COMMUNITY DEVELOPMENT DEPARTMENT REPORT

SUBJECT: H-2025-0013
Solara Estates Subdivision ALT, AZ,
PP

LOCATION: 1695 E. Amity Road, 4940 and 5060 S.
Locust Grove Road, located in the NW ¼
of Section 32, Township 3N, Range 1E.
Parcel(s) S1132223130, S1132223210
and S1132223320

C. Preliminary Plat (date: 7/30/2025)

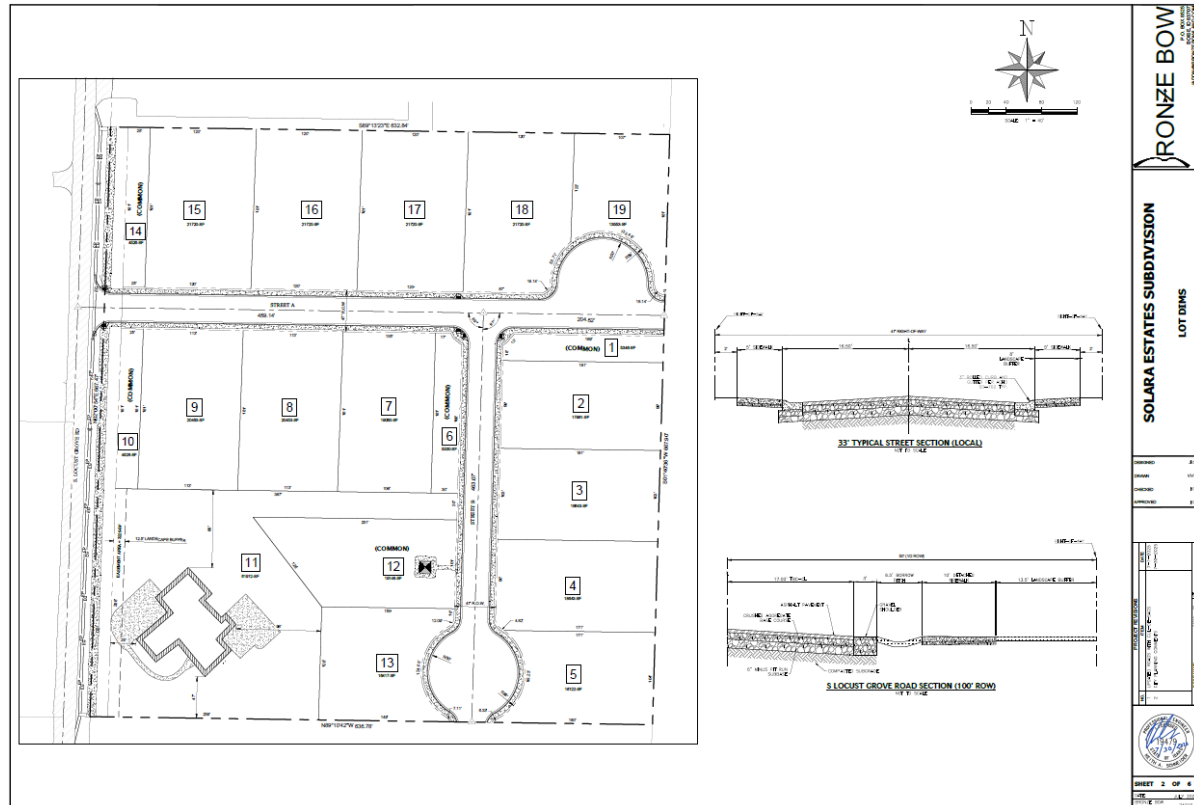
2. The Preliminary Plat included in Section VII, dated March 2025, is approved with the following revisions:
 - a. All utility easements reflected in the utility plan shall be included on the final plat.

- b. Other than the access approved with this application, direct access to S. Locust Grove Road is prohibited.
 3. The Landscape Plan included in Section VII, dated July 30, 2025 shall be revised as follows:

E. Landscape Plan (date: 8/5/2025)

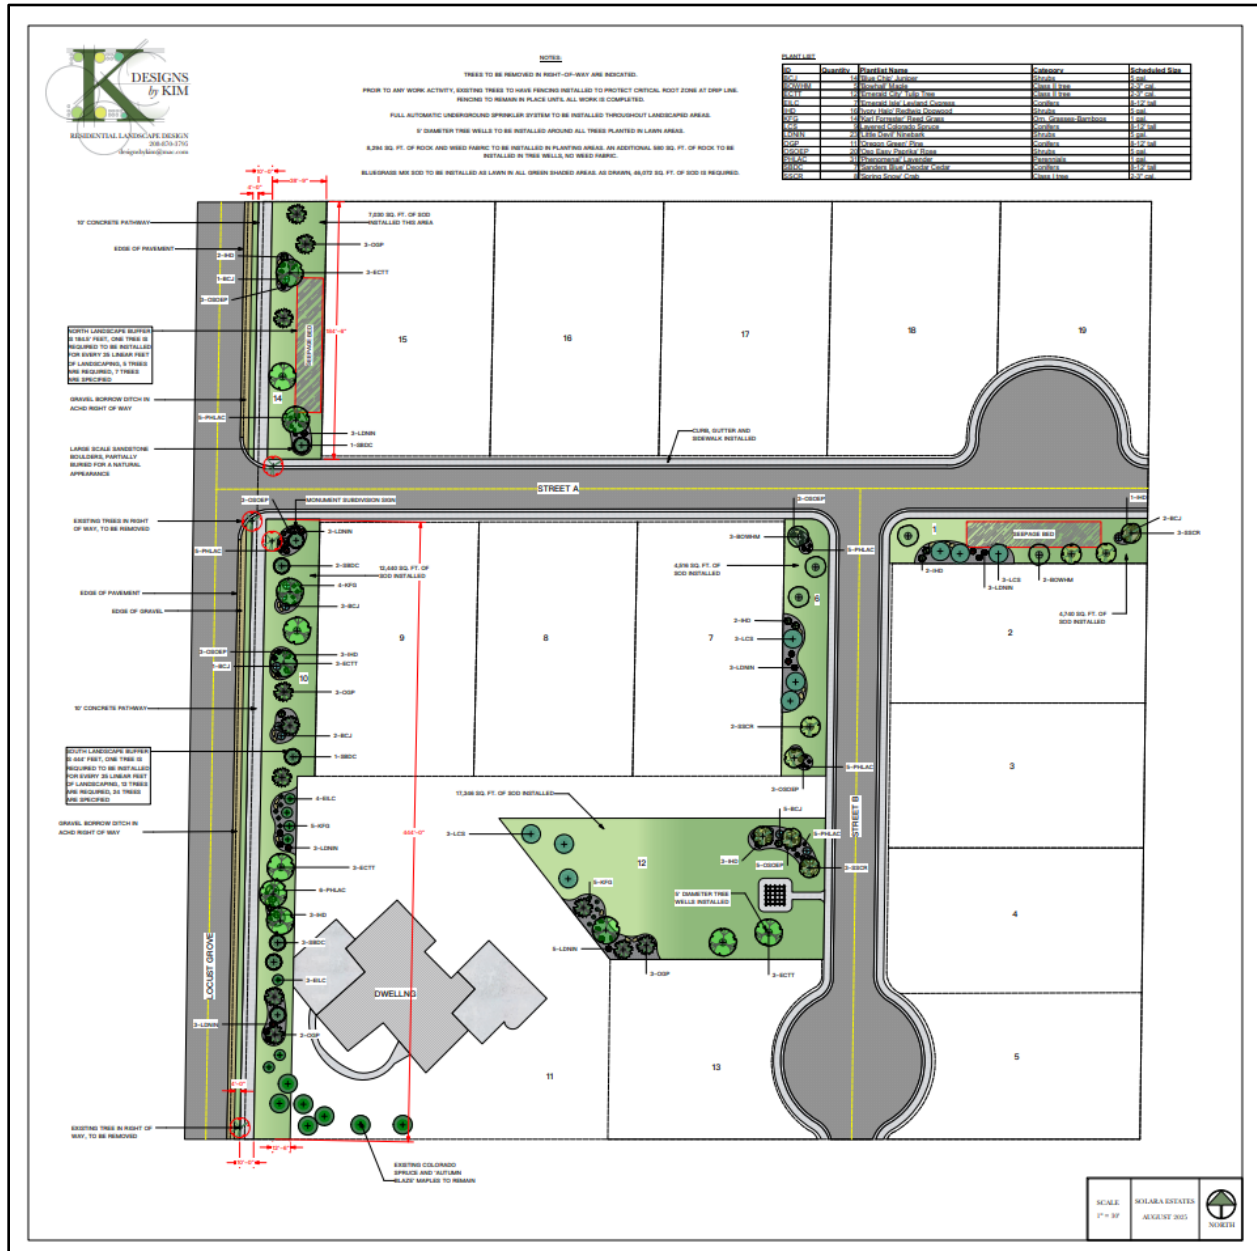
- a. Provide fence details for any proposed fences for this development.
 - b. Provide a details page for the proposed landscape.
 - c. The director has approved the alternative compliance request. The reduction in the landscape buffer for Lot 11 shall only be for the area around the driveway. The remaining buffer shall meet the 25-foot requirement.
